<b>marantz®</b> <b>SERVICE BULLETIN</b>		Date: 15-May.-2003	Model: DV4300
		Page: 1 / 1	REF.NBR: MZ03-014
Circulation:		Subject:	
Application:		The unit doesn't work pushed ON/ OFF button of the remote controller RC3200.	
x for information customer complaint in case of service mandatory .....		Int.ref:	
See Below

<b>marantz®</b> <b>SERVICE BULLETIN</b>		Date: 25-Feb.-2004	Model: DV4300
		Page: 1 / 2	REF.NBR: MZ04-016
Circulation:		Subject:	
Application:		By crack of Laser Pickup slide shaft, Pickup stops moving and cannot playback the Disc.	
x for information customer complaint in case of service mandatory .....		See below	
		Int.ref:

<b>marantz®</b> <b>SERVICE BULLETIN</b>		Date: 30-June-2003	Model: DV4300
		Page: 1 / 1	REF.NBR: MZ03-027
Circulation:		Subject:	
Application:		FFC and Top Cover short-circuit, and the unit can't be operated.	
x for information customer complaint in case of service mandatory .....	See Below	Int.ref:

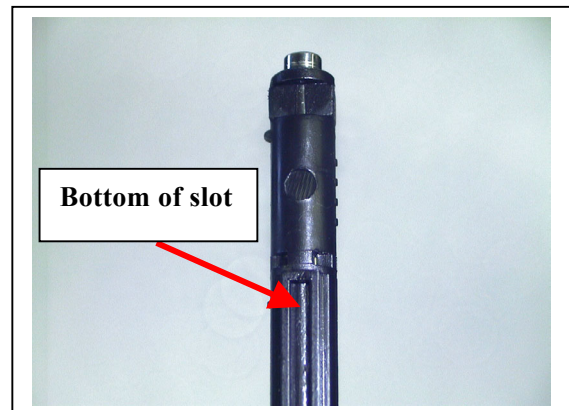
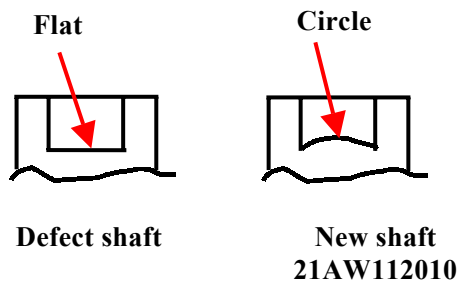
The part defect of the Laser Pickup slide shaft.  
(It occurs only in specific serial number because defective plastic part mixing.)

Difference of a shaft, the bottom form of slot is different.

- 1) **Replace the Laser Pickup slide shaft** of Loader Assy.
- 2) **Old Loader Assy Type no. RL-A700 corresponds.**
- 3) New Loader Assy Type no.DSL-710A does not correspond.

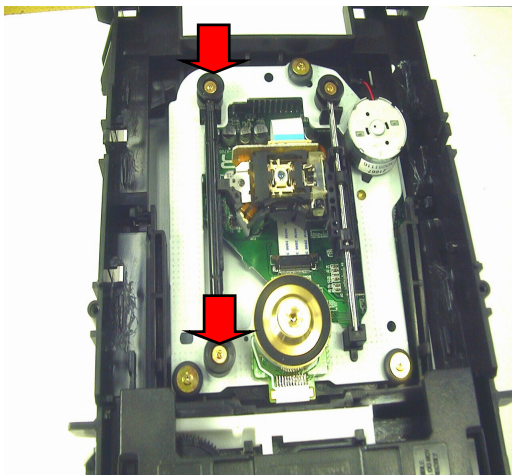
- 1. Open the disc tray.
- 2. Remove 2 screws.
- 3. Push 2 hooks to inside and remove the cover.

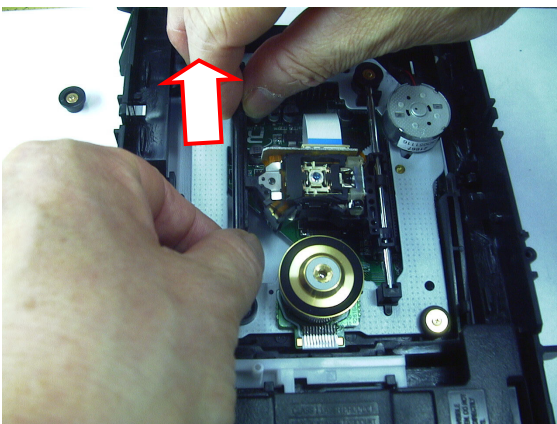
- 4. Remove 2 screws and remove plastic ring.

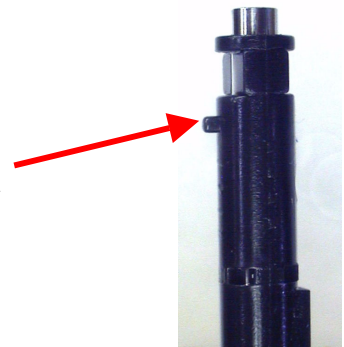
- 7. Attach the New Laser Pickup slide shaft

This projection is the DISC outside.

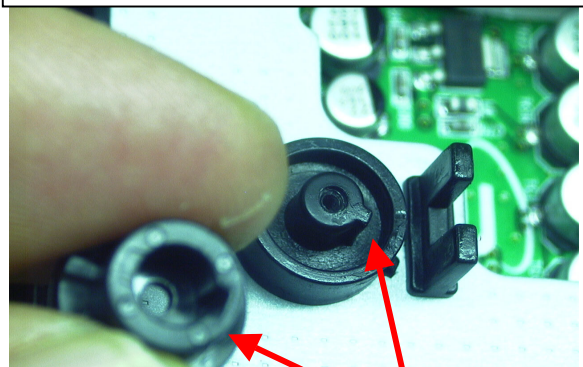
- 8. Attach Plastic ring and screws

Set projection and a slot

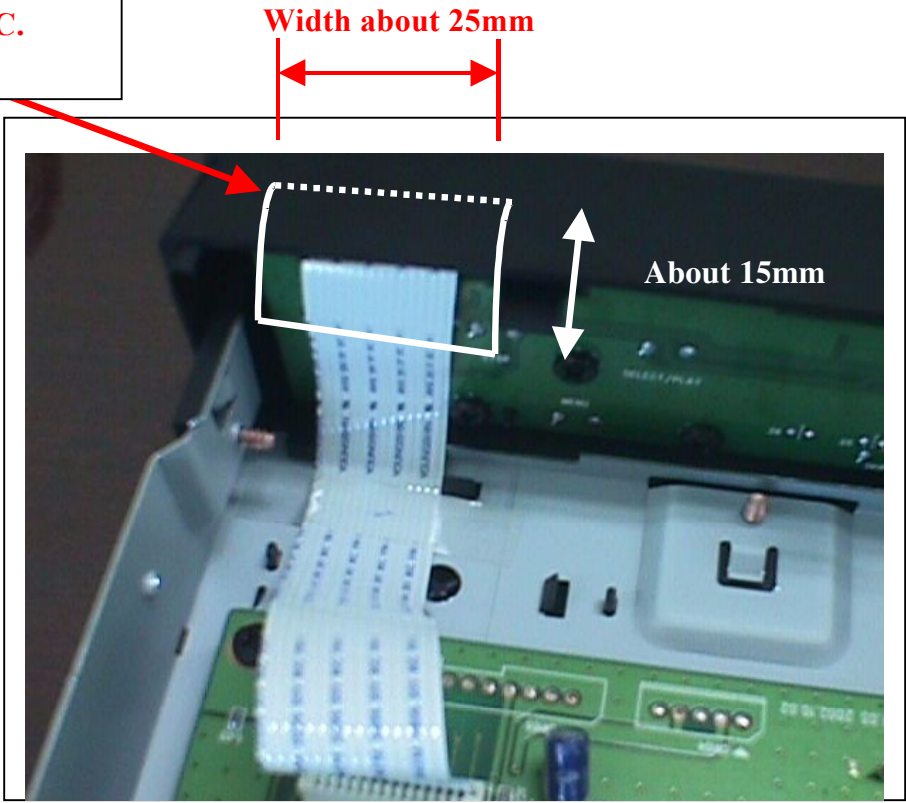
The insulation of Flexible Flat cable can be torn, and it short-circuits with Top cover, then can't be operated. Specially, the insulation of FFC which touches the tip of the Top Cover can be torn.

The insulator tape put on FFC.  
Especially, the place where the tip of the Top Cover touches FFC.  
The tape to use is **3M Scotch Filament Tape #895-2-206 or the equivalent.**

**You must put 3M Scotch tape in the point where the tip of the Top cover touches FFC.**
